3.8.10 Traffic and Transportation Comments and Responses

Lost Lake Resort

Town of Forestburgh, Sullivan County, New York

FEIS Figure 3.8-1: Conceptual Traffic Routing - Phase 1

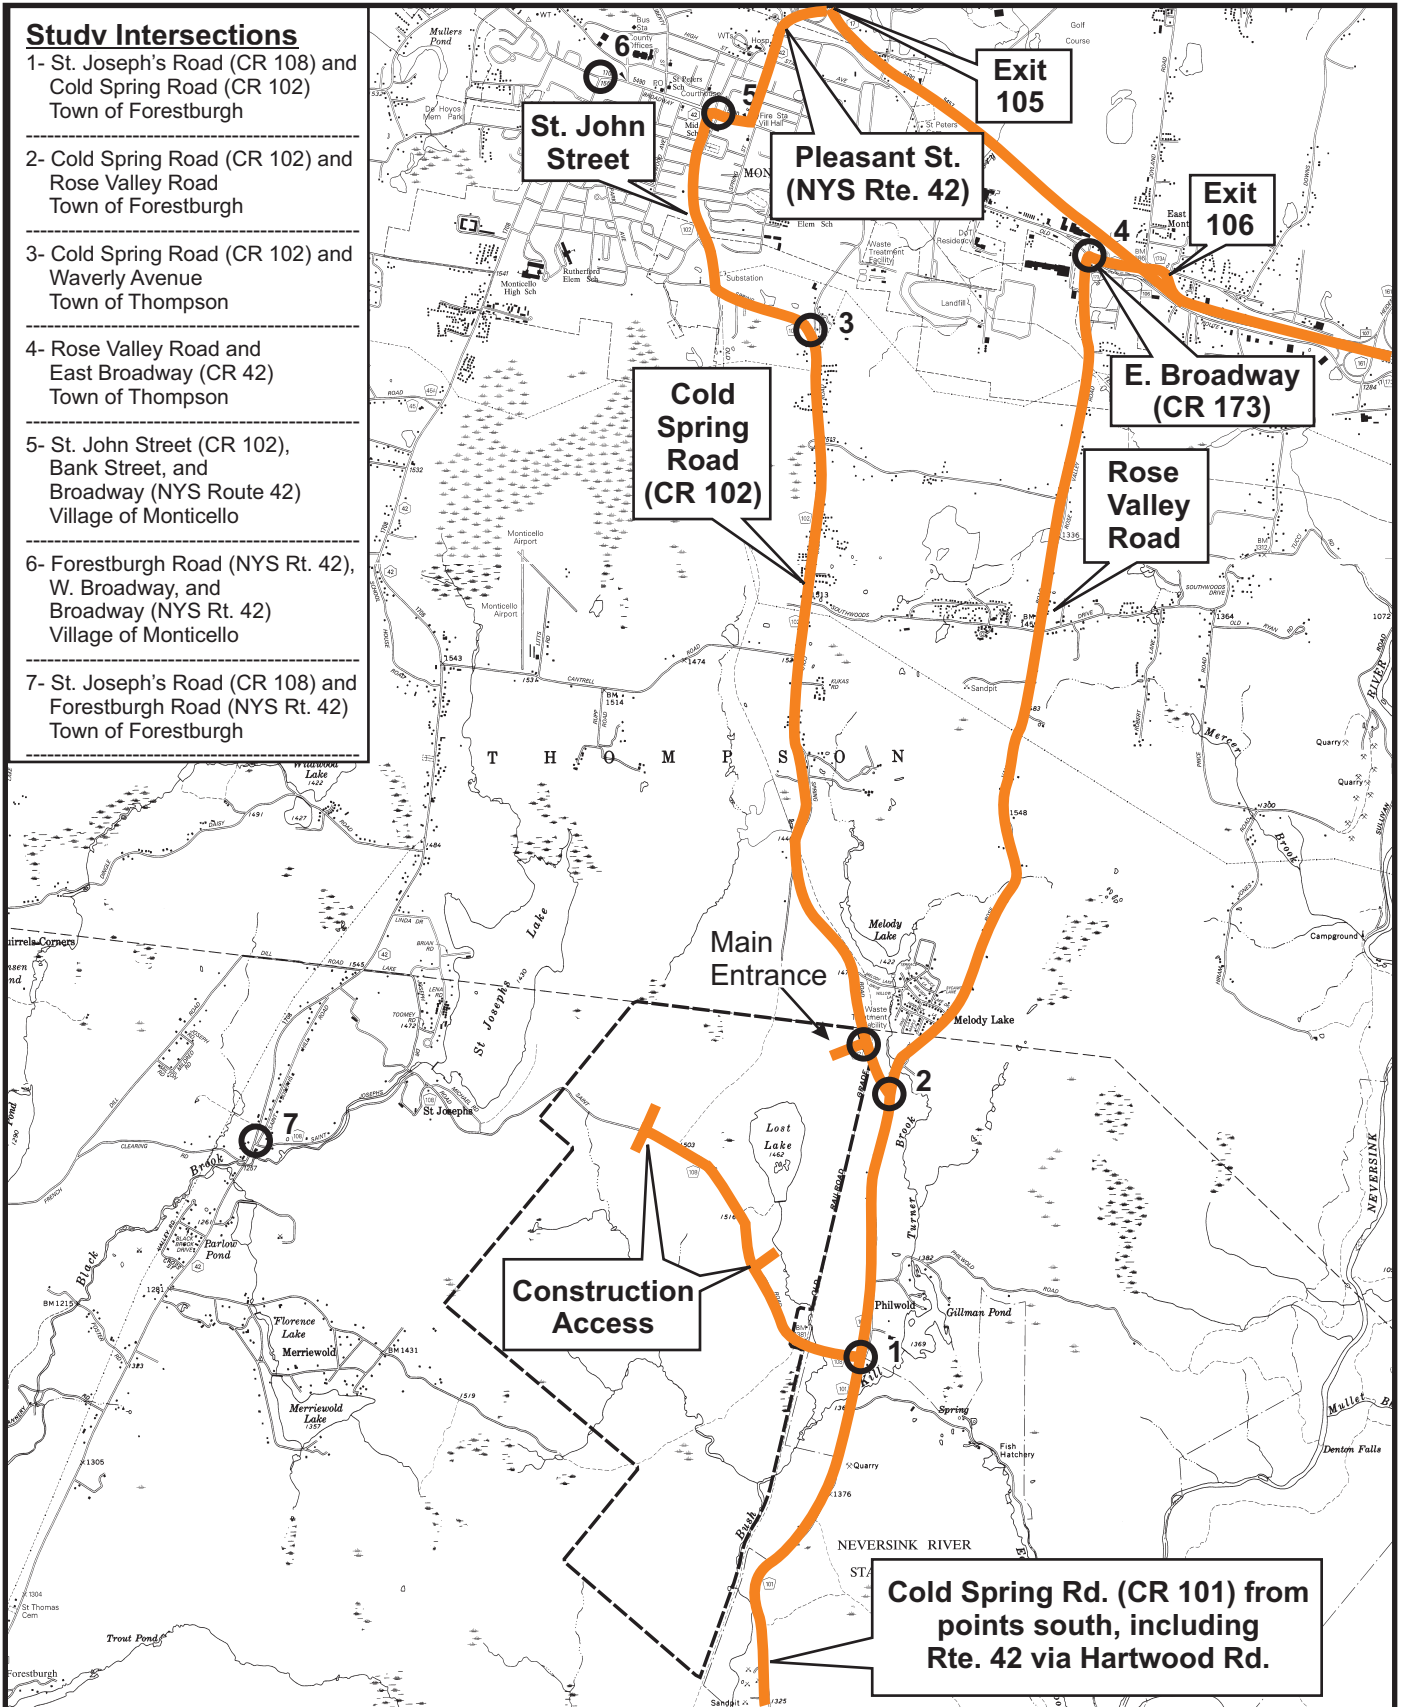
Comment 3.8-2 (Letter 4, CT Male Associates, July 1, 2010): Construction Traffic: Provide an estimate of the net importation of construction materials required for the project. During the construction period, what is the range of truck trips that will be required on a daily/weekly basis? Will dedicated truck routes be specified?

Response 3.8-2: *Approximately 8 to 10 small vehicles (pick-up trucks and van size) and 3 to 4 material deliveries (box truck and flatbed) are estimated to arrive at the site on a daily basis during project construction. This activity will be during daylight hours. In some cases when the source of materials or destination of surplus materials is known, dedicated truck routes will be specified as part of the construction contractor agreements. Each year the posted and R-post bridge lists from the NYS DOT website² will be reviewed. There is currently an R-Post Bridge on US Route 6 in Port Jervis. The R-Posting will prohibit overweight loads on that route without a waiver permit. None of the other study area roads have R-postings or weight restrictions in the site vicinity, including NYS Route 42 in the Towns of Thompson and Forestburgh and the Village of Monticello as of July 2010.*

As stated in the DEIS, the Applicant will work with the Town and County to identify desired truck routing before construction commences. A conceptual traffic routing plan for Phase 1 construction is shown in FEIS Figure 3.8-1. This mitigation plan will be designed in detail, with the input from the Town of Forestburgh, Town of Thompson and Sullivan County Highway Superintendents, prior to each phase of construction to identify the specific truck routes depending on vehicle size and weight, and origin. The construction traffic arriving from out-of-town will be routed primarily on State and County roads: from the north via NYS Route 17 at Exit 106 using CR 173A (East Broadway) and Rose Valley Road (a Thompson town road), or from the south via NYS Route 42, CR 48 (Hartwood Road), and CR 101 and 102 (Cold Spring Road).
